JOINT REGIONAL PLANNING PANEL (Sydney West Region)

JRPP No	2015SYW136
DA Number	DA/2014/228/2
Local Government Area	Camden
Proposed Development	Section 96(2) Modification – Amendments to the approved lot layout, addition of 9 residential lots, amendment to drainage basins and amendments to conditions of consent
Street Address	116 Oran Park Drive, Oran Park
Applicant/Owner	Harrington Estates Pty Ltd C/- Design and Planning
Number of Submissions	None
Regional Development Criteria (Schedule 4A of the Act)	Section 96(2) Modification Application
List of All Relevant s79C(1)(a) Matters	<ul style="list-style-type: none"> • State Environmental Planning Policy (State and Regional Development) 2011 • State Environmental Planning Policy (Sydney Region Growth Centres) 2006 • State Environmental Planning Policy (Infrastructure) 2007 • State Environmental Planning Policy No 55 – Remediation of Land • Deemed State Environmental Planning Policy No 20 – Hawkesbury-Nepean River • Camden Growth Centres Precincts Development Control Plan

PURPOSE OF REPORT

PROPOSED PLAN OF SUBDIVISION

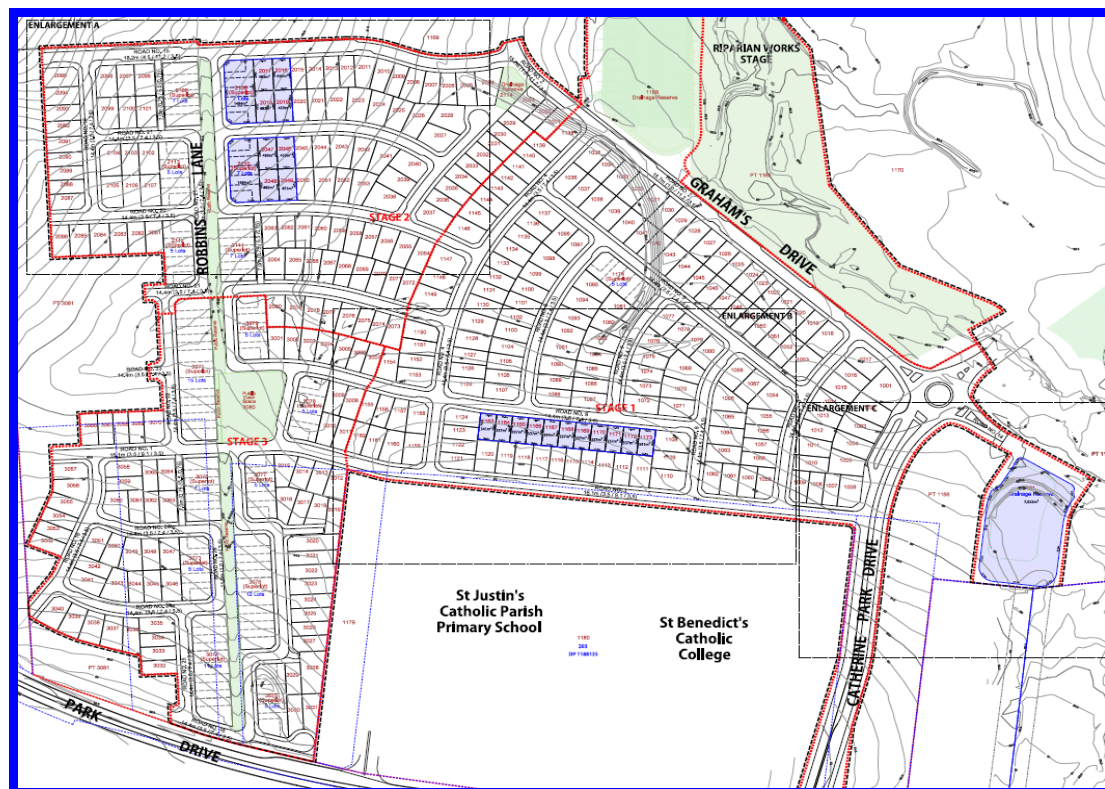
- Amend the dimensions of superlots 2109 and 2110;
- Amend the dimensions of lots 1059, 1060, 1061, 1062, 1069, 1070, 1082, 1083, 1084, 1099, 1100, 1144, 1145, 1160, 1161, 2016, 2017, 2018, 2019, 2046, 2047 2048 and 2049;
- Subdivide superlots 1163 and 1164 to provide 9 additional residential lots measuring between 337m² - 341m² each.
- Combine the approved drainage basins 12a and 12b into one single basin.
- Amend the wording of conditions numbered 1(4), 1(7), 1(15), 2(2), 2(24), 2(26), 5(1), 6(10), 6(15).

AMENDED LOT BOUNDARIES

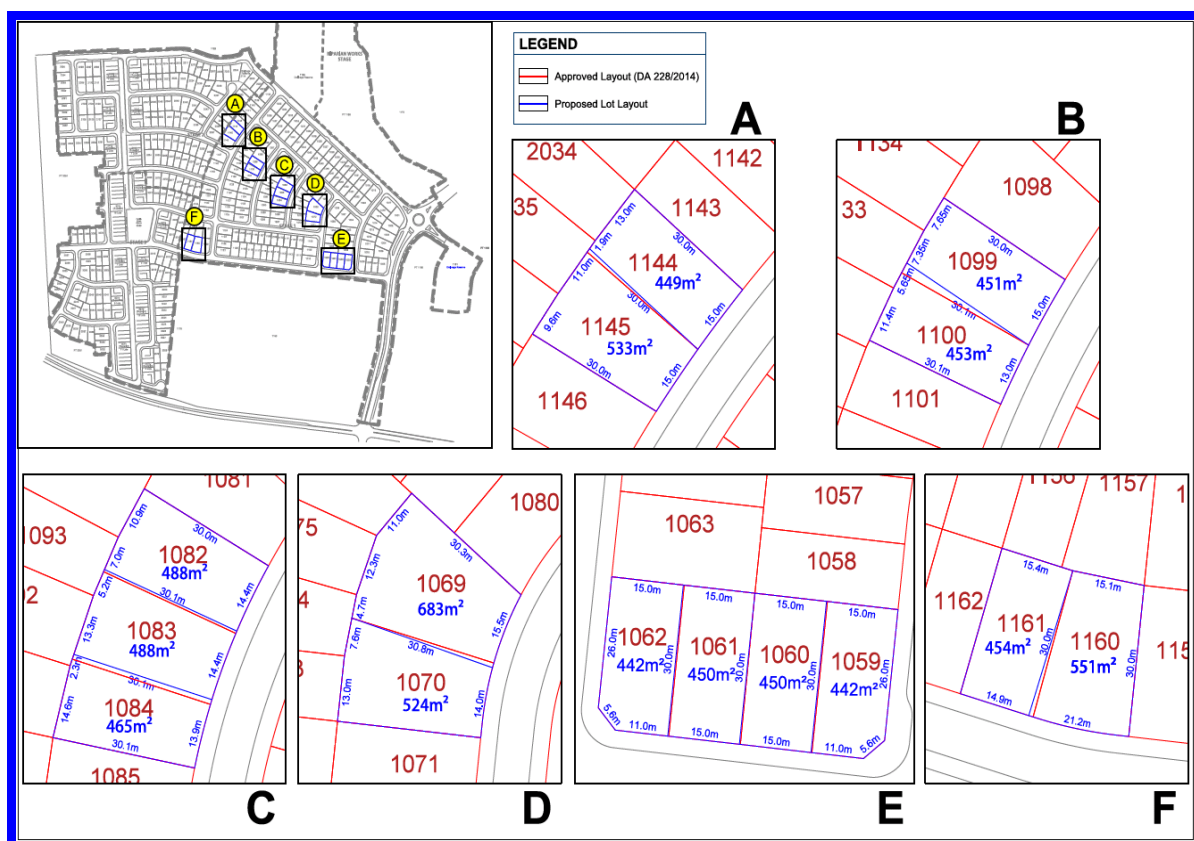
The modification proposes to amend the dimensions of 2 superlots and 23 residential lots, subdivide 2 superlots to provide 9 additional residential lots, combine 2 approved drainage basins into one single basin and amend the wording of a number of conditions of the consent.
